From: Nearhoof, Frank [Frank.Nearhoof@dep.state.fl.us]
Sent: Thursday, January 11, 2007 7:45 AM
To: Piccone, Tracey
Subject: RE: Request for approval for Minor Revision to Long-Term Plan

From: Piccone, Tracey
Sent: Monday, November 27, 2006 2:34 PM
To: Nearhoof, Frank
Cc: Powell, Dean; Drum, Deborah
Subject: Request for approval for Minor Revision to Long-Term Plan

Hi Frank,
As a follow-up to our phone call today about discontinuing monitoring and not installing new monitoring equipment at the G-253s, we would like to request approval for a Minor Revision to the Long-Term Plan for

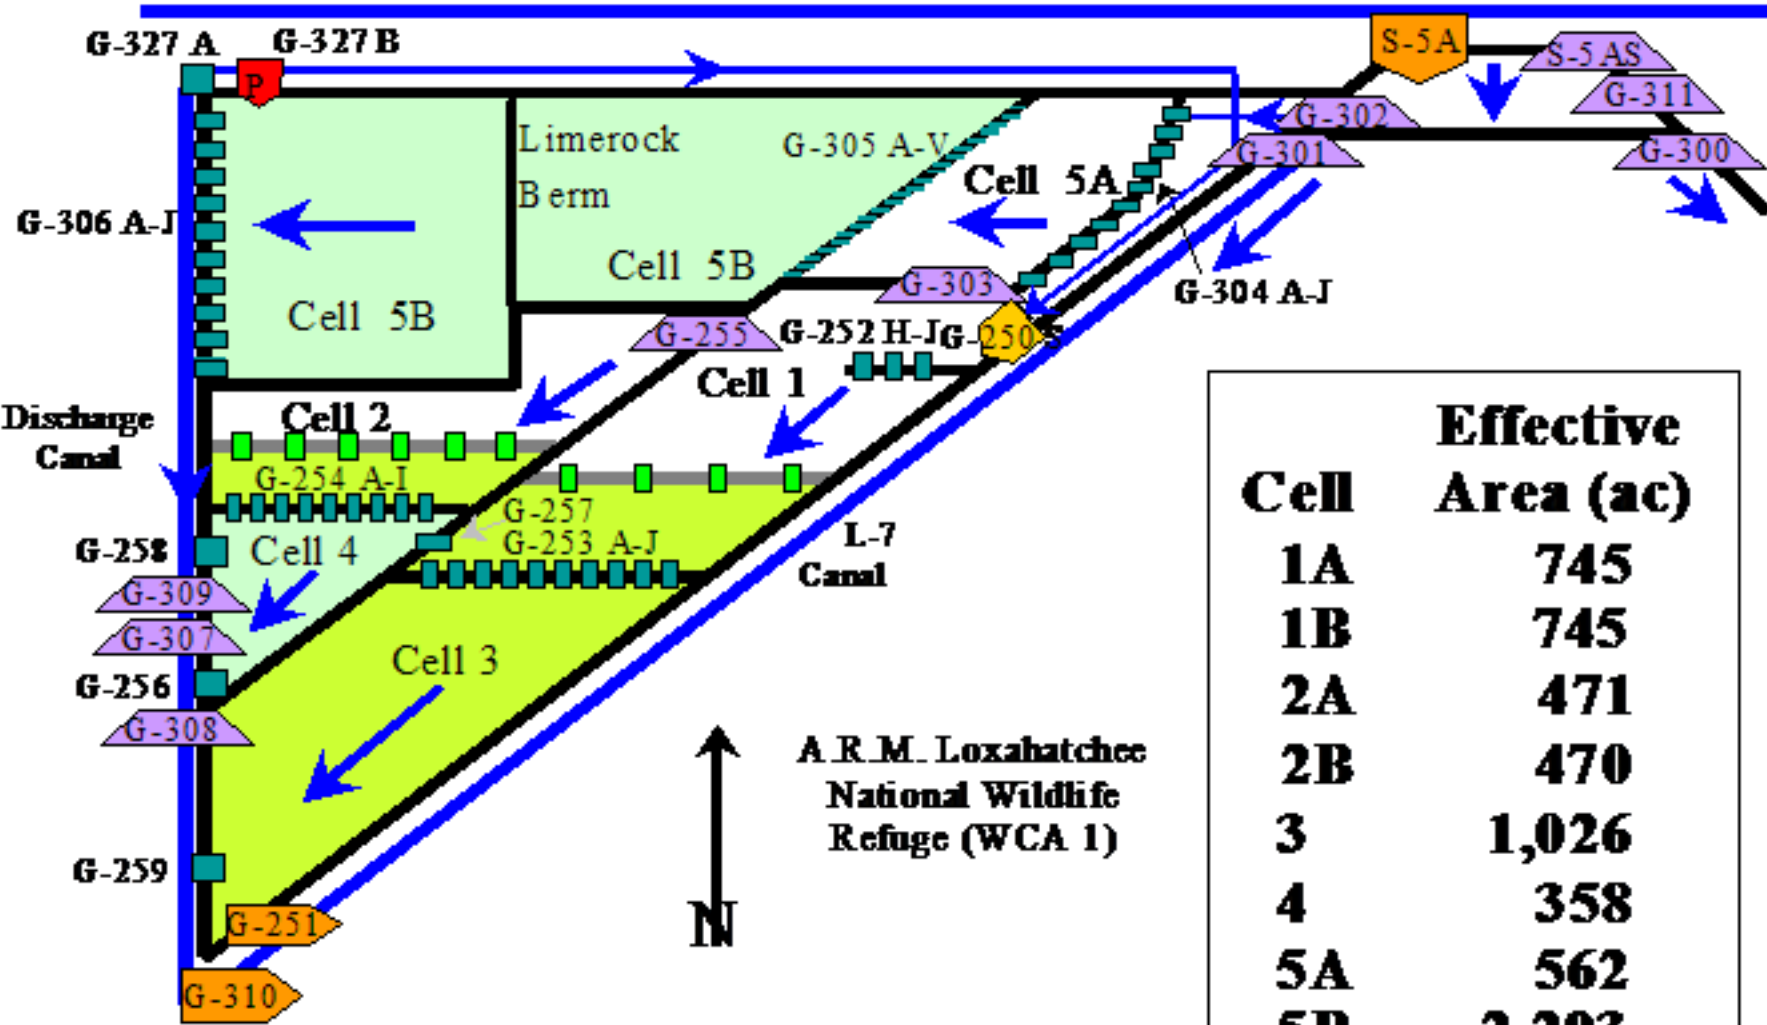
this change.

When the Long-Term Plan was developed, the monitoring at this levee (actually at 2 of the G-253 culverts - see map below or see attached file) was shown to continue even after the new Cell 1 levee was complete. The internal culvert monitoring that is in Part 8 of the Long-Term Plan is under "Operational Monitoring - BC05", and the specific monitoring locations are shown on Page 8-9 in Table 8.7. It is proposed that with the new levee monitoring information, we will have sufficient information about this flow-way without needing to continue the G-253 monitoring. For this reason, it is proposed that this revision will not have significant impact on scope or schedule. It is also proposed that this revision will not have significant cost impacts (approximate savings of \$80,000 per year).

Thanks, Tracey. I don't know where the original e-mail got to. We have reviewed the information you have provided & concur that this proposal constitutes a minor revision under the revision classification set forth in Section 1.10.3 of the Long-Term Plan. We believe this revision is consistent with the adaptive implementation process for the Long-Term Plan envisioned under the Everglades Forever Act and that the cost savings from this revision can be put to better use elsewhere. Therefore, the Department hereby approves the District's proposed revision. Please note that a description of this revision must be included in the 2008 South Florida Environmental Report, as required by Section 1.10.4 of the Long-Term Plan. Please contact me if you have any questions regarding this approval. FLN
